**TOWN OF WINTER PARK  
PLANNING COMMISSION**  
Tuesday, September 10, 2024 8:00 AM

- a. Minutes – August 27, 2024
- b. Minor Site Plan - Riverwalk at Winter Park - Lot 18 – 135 Apres Way (PLN24-048)
- c. Minor Site Plan - Riverwalk at Winter Park - Riverfront Pavilion (PLN24-046) and Central Amenity Area and Entry Gates (PLN24-047)

**TO** Planning Commission  
**FROM** James Shockey, Community Development Director  
**DATE** September 10, 2024  
**RE** Riverwalk at Winter Park, Lot 18 (PLN24-048)

**A1.0**

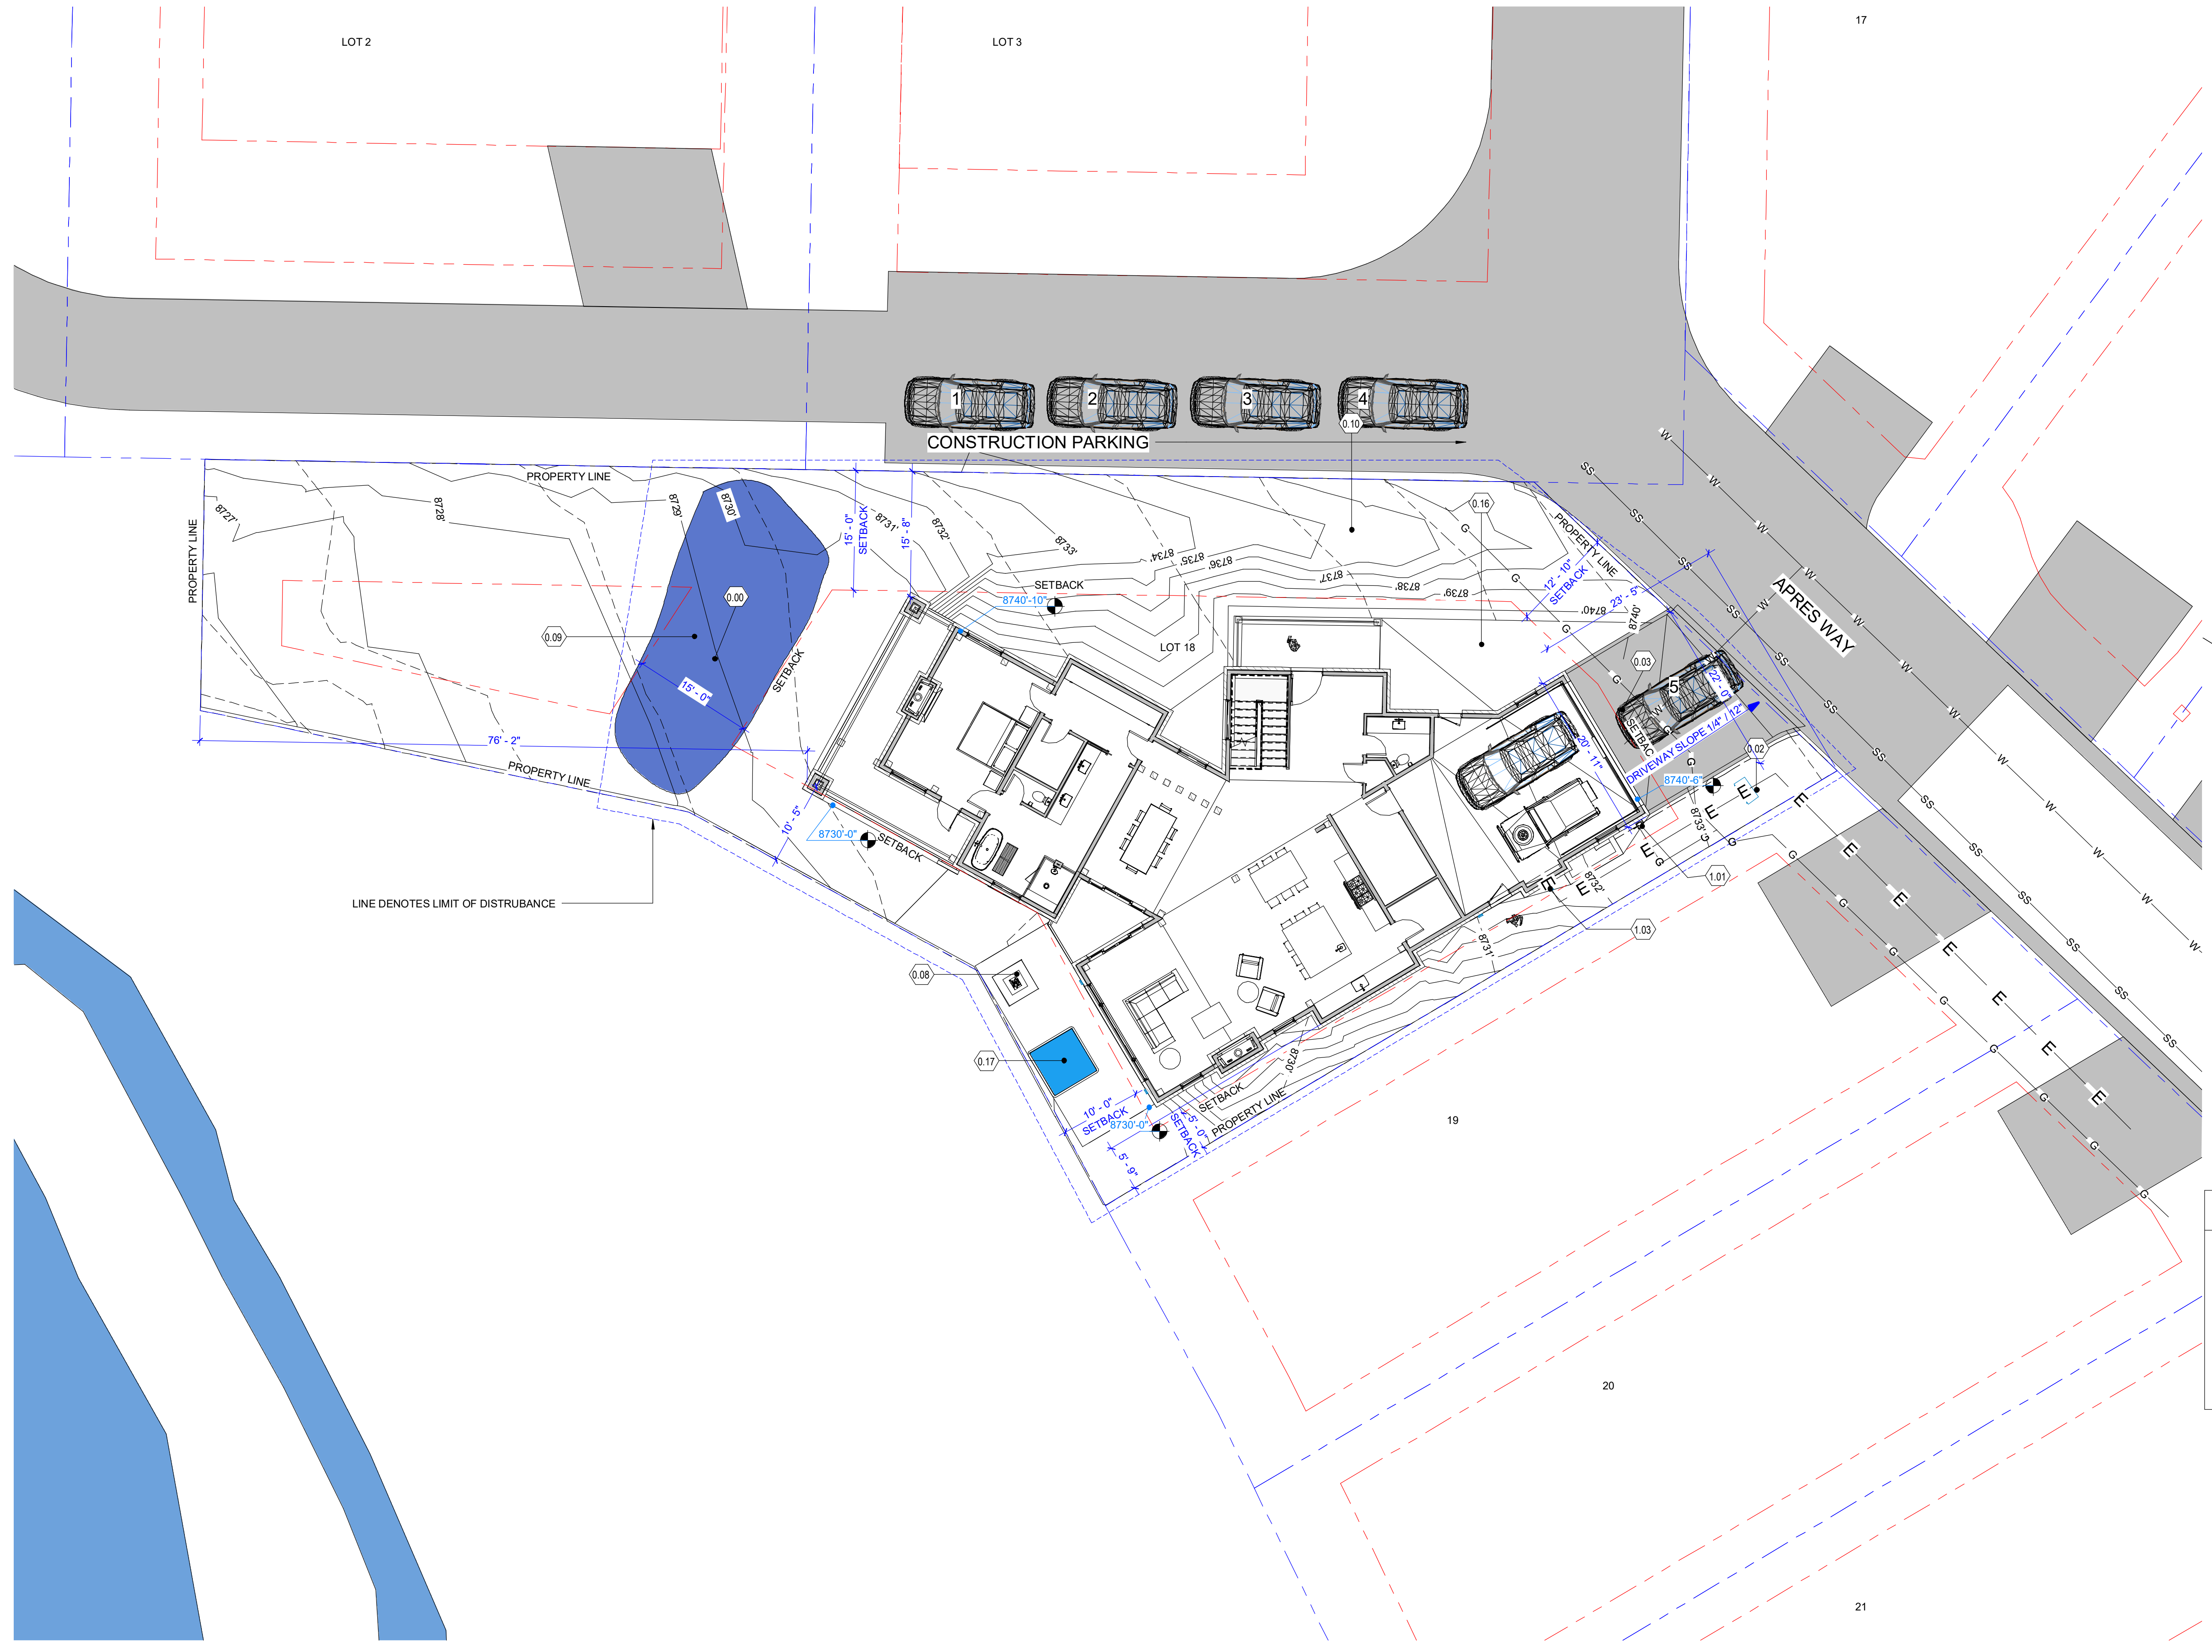
Unsatisfactory. Overall, the Site Plan for Lot 18 provides all information required for staff review; however, there are two additional items that must be clarified. First, a five-foot tall, three-rail fence is proposed on the western and northern property lines per the FDP but the site plan does not show the fence. Secondly, the Limit of Disturbance line extends beyond the property line.

- Identify the structure on the southside of the garage, it appears to be a step, but there is no door. The structure identified encroaches the 5-ft side setback approximately 3 inches.
- Applicant shall remove or relocate the fire pit and hot tub from the proposed location in the rear setback. Alternatively, the Applicant may seek a setback variance from the Board of Adjustment.
- The structure on the south side of the garage shall be modified to stay within the 5-ft setback.

- Update the site plan to reduce total building coverage by approximately four percent (4%) to meet the 40 percent (40%) building coverage requirement.

Partially satisfactory. The FDP has an approved Snow Storage Plan; however this submittal does not include site specific snow storage locations. According to the approved snow storage plan, snow storage is located on the subject property. Provide snow storage locations and amounts on the Site Plan.

- Applicant shall verify when the proposed fence approved with the FDP will be constructed, and if it will be constructed on the subject property.
- Provide clarity in site plan notes that adjacent properties that are under separate ownership will not be disturbed permanently nor temporarily during all phases of construction. Specifically, show that the limit of disturbance does not include any of the adjacent jurisdictional wetlands.

- Applicant shall provide a snow storage table that includes landscaped area, hardscape area, required snow storage, and provided snow storage.

**A3.1**

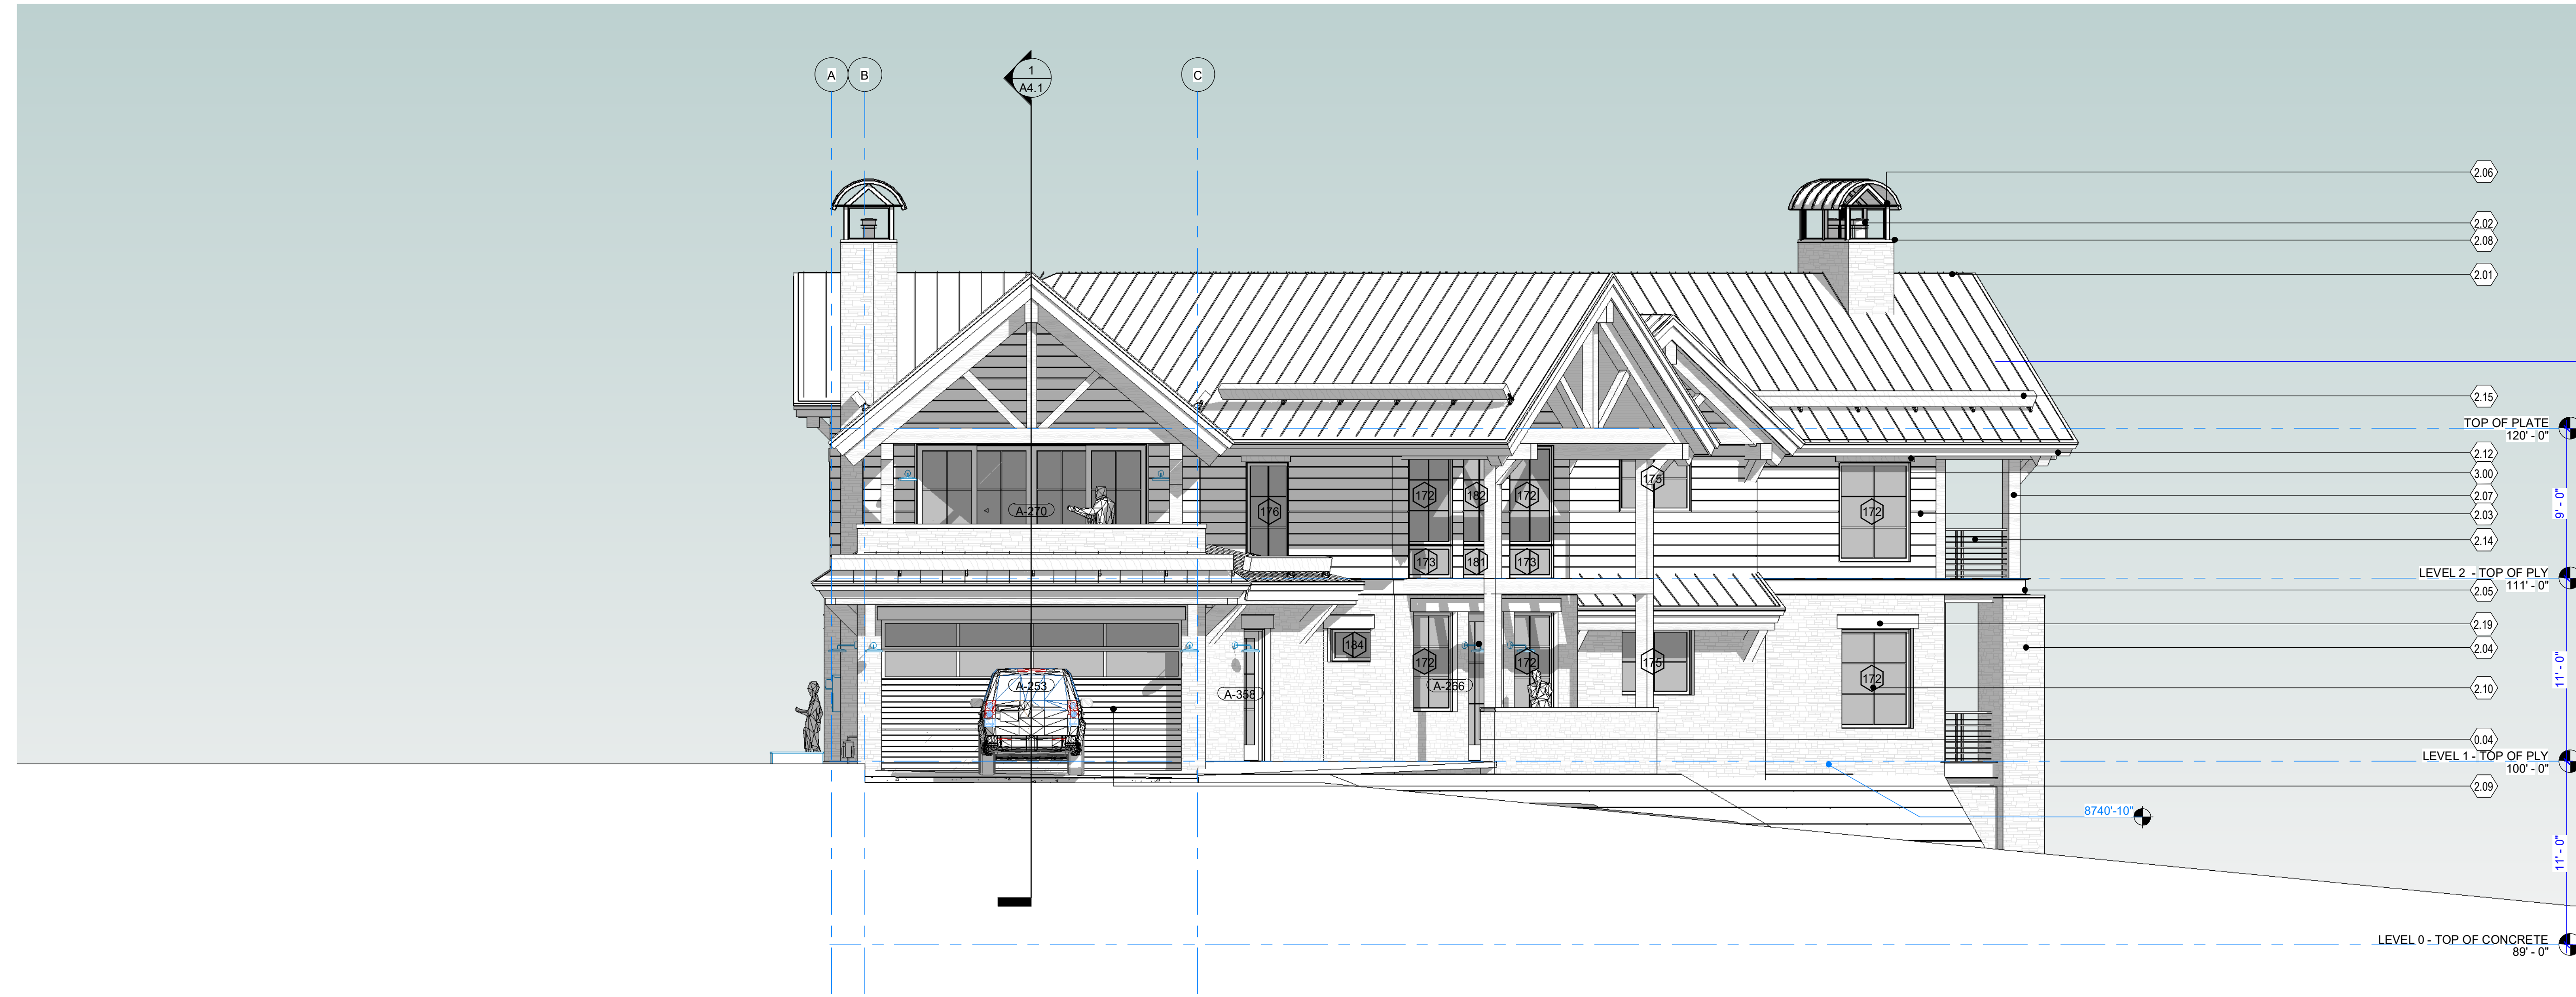
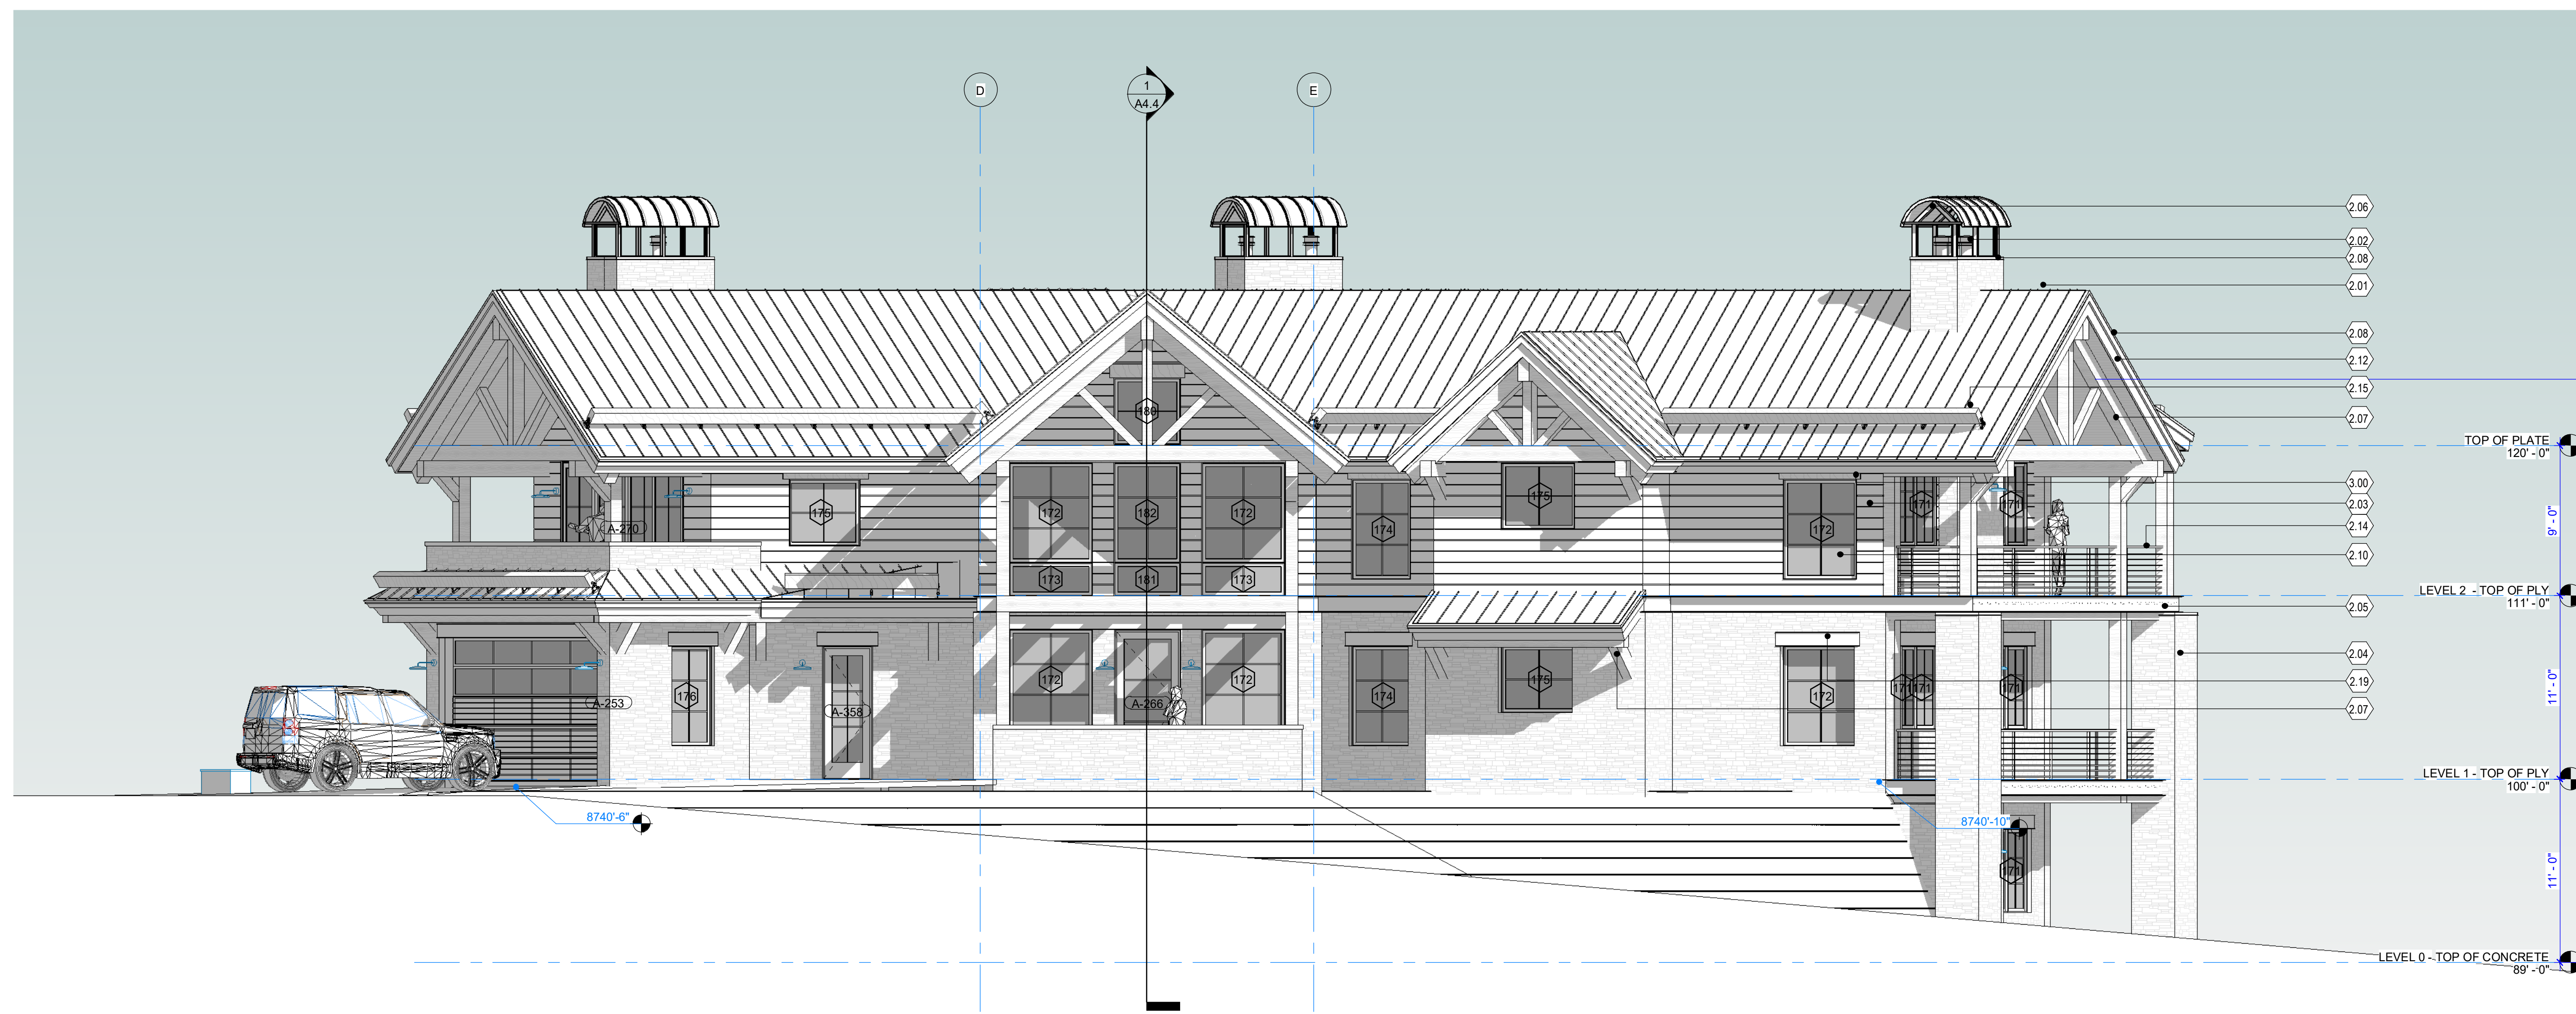
Unsatisfactory. Elevation plan includes all materials required for review. As previously noted, the proposed building is compliant with the Winter Park Design Guidelines. Elevation markers do not provide enough information for staff to properly measure height.

Unsatisfactory. The elevation plans accurately state the maximum height of 35-feet, per the Riverwalk FDP but the height appears to be measured from "concrete". As previously noted, the Elevation plan shall be updated so that building height may be accurately reviewed for compliance.

- The Elevation plans shall be modified to accurately depict and measure building height from top of existing grade or top of exposed foundation.
